Response to REP2-034 (WRs Part 1b of 5 Members of the public and businesses)

Author: Michael Reddington

1 Responses to 'Luton Rising's Response' column in REP2-034

Figure 1: Simplified Air Contour Schematic - Daytime (Red) and Night-time (Blue) for Residential Properties

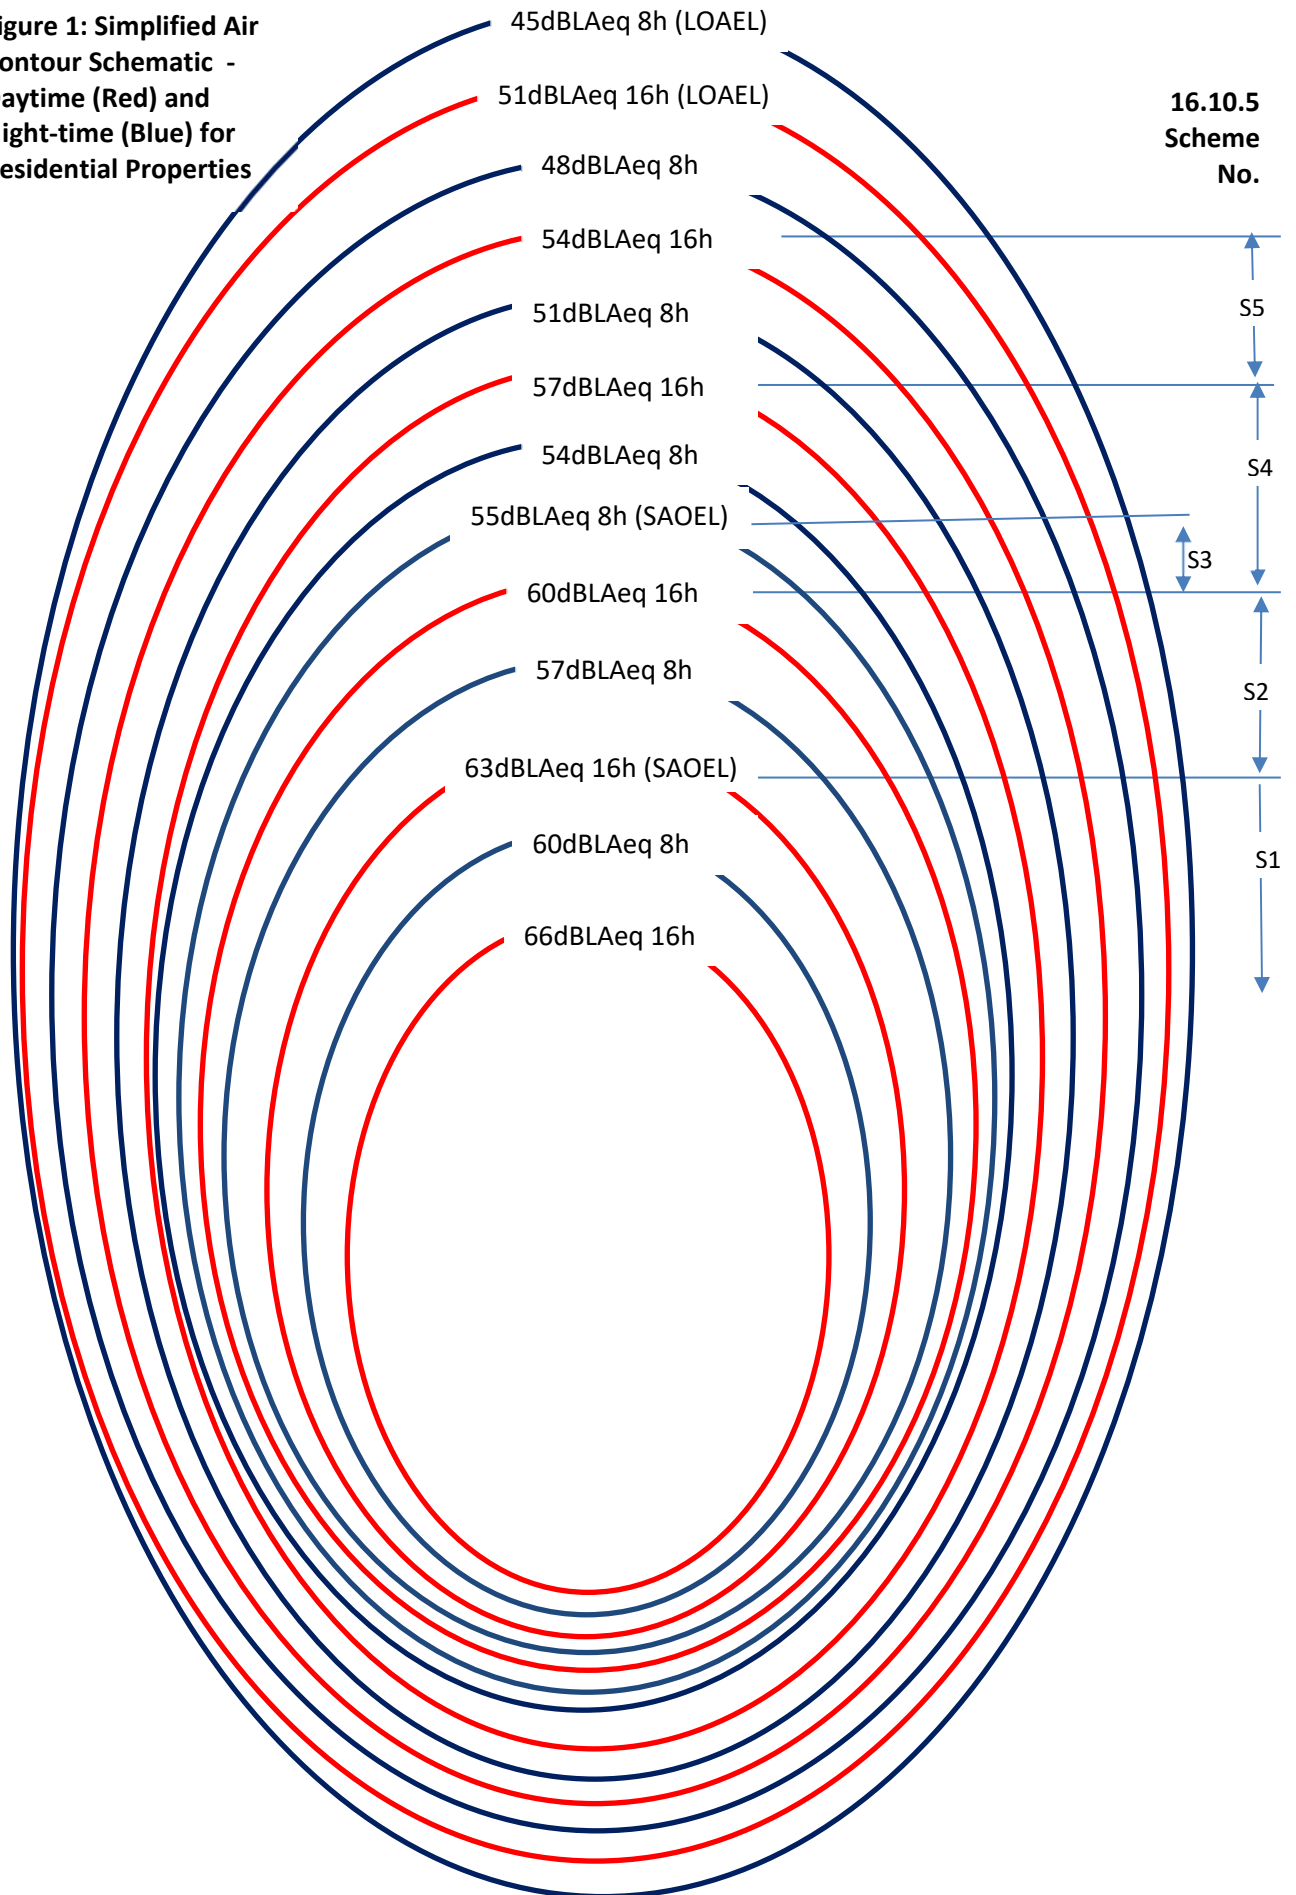
Response #	REP2-034 Page/Row	Comment
		<p>Phase 1 that would be eligible for compensation. This is incorrect. Paragraph 16.9.147 actually states:</p> <p><i>“16.9.147 During the night-time, of the population of 3,250 exposed to noise between the SOAEL and UAEL experience noise increases of 1-2.9dB corresponding to a minor to moderate adverse effect resulting in an adverse likely significant effect as the exposure is above SOAEL. This population is illustrated in Figure 16.68 in this ES [TR020001/APP/5.03] and includes the community areas listed in Table 16.53. This population would be eligible for a full package of noise insulation which would avoid the significant effects (see Section 16.10 and Section 16.11). By assessment Phase 2b noise insulation will have been rolled out to all the communities in Table 16.53 should they take up the offer in a timely manner. “</i></p> <p>BUT if one studies the ‘Scheme 3’ details and Figure 1 below, it becomes obvious that something is seriously wrong. Scheme 3 only applies to properties with Night-time Noise levels between contours defined by 55dBLAeq 8h (SOAEL) and Daytime contour 60dBLAeq 16h.</p> <p>In other words if the Night noise level experienced by a receptor is greater than the contour defining 60dB LAeq, 16h (for example 57dBLAeq 8h) there is NO compensation for Night-time Noise.</p> <p>This is clearly wrong and actually contradicts 16.9.147 which implies that all properties subject to Night-time noise level in excess of SOAEL up to UAEL will be eligible for Scheme 3.</p> <p>In addition it is implied that the 3,250 residences could receive ‘Scheme 3’ compensation only. However, depending upon their Daytime exposure (anything from 57dB LAeq upwards) they should <u>also</u> be eligible for Daytime ‘Scheme 4’ through to ‘Scheme 1’.</p> <p>Paragraph 16.9.146 states:</p> <p><i>“16.9.146 During the night-time, the population of 59,550 exposed to noise between the LOAEL and SOAEL experience noise increases of less than 3dB corresponding to a negligible to minor adverse effect which is not significant. Of this population, the 13,250 outside the night-time SOAEL but inside the 54dBLAeq,16h contour would be eligible for noise insulation (see Section 16.10 and Section 16.11).“</i></p> <p>This paragraph would seem to imply that any property with a Night-noise level just below SOAEL of 55dBLAeq 8h (for example 54dBLAeq 8h) - only 1dB below SAOEL - would be eligible for ‘Scheme 4’ or £6,000, a Daytime compensation; whereas a night-time level of 51dBLAeq 8h would be eligible for Day-time Scheme 5, or £4,000.</p>

Response #	REP2-034 Page/Row	Comment
		<p><u>But, this money cannot be spent on insulating bedrooms as it applies to 'habitable' rooms only!</u></p> <p>This seems iniquitous bearing in mind that receptors are more sensitive to 54dB LAeq 8h – only 1dB below SOAEL - than they are to 54dB LAeq 16h. Yet compensation is payable for Day-time noise down to 54dB LAeq which is 9dB below SOAEL and there is no Night-time compensation at all below SOAEL.</p> <p>The Applicant should revisit these proposals immediately and come up with a more equitable solution.</p> <p>One further observation, on Programme. Chapter 16 paragraph 16.9.147 slips in the following: “... By assessment Phase 2b noise insulation will have been rolled out to all the communities in Table 16.53 should they take up the offer in a timely manner.”</p> <p>The Applicant is stating that it could take him up to 2043 to provide insulation to homes in Phase 1 with noise levels above SOAEL! This is unacceptable and only goes to demonstrate the Applicant’s lack of concern for resident’s health. This gives a lie to previous statements where the Applicant was going to ‘prioritise’ insulation for worst-affected homes. e.g. Page 173 paragraph 2:</p> <p><i>“The Draft Compensation Policies Measures and Community First document contains a commitment, in paragraph 6.1.14 to prioritise the most affected properties within the latest 63dBLAeq,16h and 55dBLAeq,8h contours and introduce each scheme as efforts to insulate those in worst affected contours are complete. “</i></p> <p><i>And in response in REP2-034 Page 216 Row 2:</i></p> <p><i>“The Applicant is making a commitment to prioritise areas for noise insulation based on those most significantly impacted. Whilst roll-out will be proactively managed by the airport operator a programme has not been specified because the take up rate and speed of take up cannot be regulated by the Applicant (see Draft Compensation Policies Measures and Community First [TR020001/APP/7.10] “</i></p> <p>The Applicant must provide an undertaking to ensure that mitigation is in place before the anticipated noise level increases begin. A suitable Programme for insulation needs to be submitted for comment forthwith.</p> <p>ExA We would be very grateful for the ExA to instruct the Applicant to do the following:</p>

Response #	REP2-034 Page/Row	Comment
		<ol style="list-style-type: none"> 1. Carry out a check on the Noise Contour drawings and amend as necessary 2. Revisit the mitigation measures and come up with a clearer and more equitable proposal for Night-time Noise 3. Assess any consequential impacts on Non-residential properties compensation and update DCO Application as necessary 4. Provide an undertaking to ensure that noise mitigation is in place before the anticipated noise level increases begin. 5. Provide a Programme of insulation that prioritises the Significant health impacts on residents <p>ExA We would be grateful if the ExA would secure Items 4,5 and 6 as a Planning Condition once approved .</p>
